UNIVERSITY VILLAGE SUBDIVISION

APPLICATION NUMBER 25 DATE September 16, 2004

REQUEST Subdivision

UNIVERSITY VILLAGE SUBDIVISION

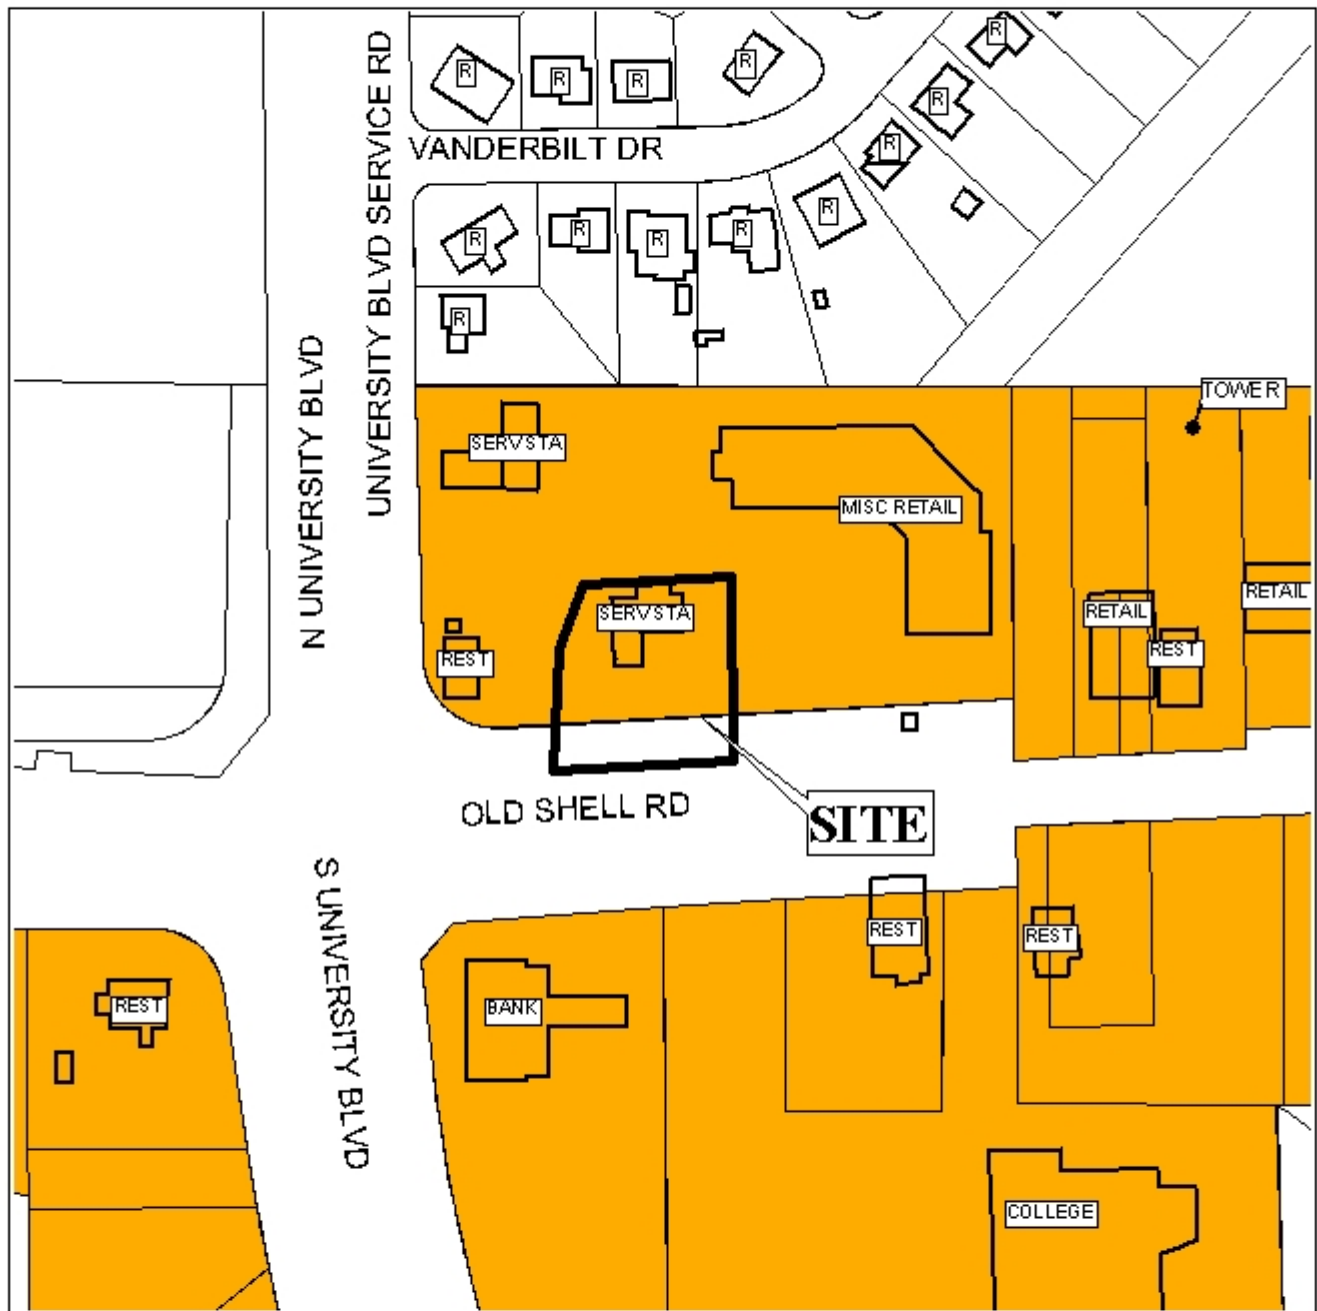
The plat illustrates the proposed 1 lot, 0.7 \pm acre subdivision which is located on the North side of Old Shell Road, 125' \pm East of University Boulevard and is in City Council District 7. The subdivision is served by public water and sanitary sewer.

The site fronts Old Shell Road, a planned major street, and the existing right-of-way is not shown. The Major Street Plan requires a 100-foot right-of-way; therefore, the dedication of sufficient right-of-way to provide 50-feet from the centerline of Old Shell Road should be required. Additionally, as a means of access management, a note should be placed on the final plat stating that the site is limited to one curb cut to Old Shell Road, with the location, size, and design to be approved by Traffic Engineering, should be required.

The plat meets the minimum requirements of the Subdivision Regulations and is recommended for Tentative Approval subject to the following conditions: 1) the dedication of sufficient right-of-way to provide 50' from the centerline of Old Shell Road; and 2) the placement of a note on the final plat stating that the site is limited to one curb cut, with the location, size, and design to be approved by Traffic Engineering.
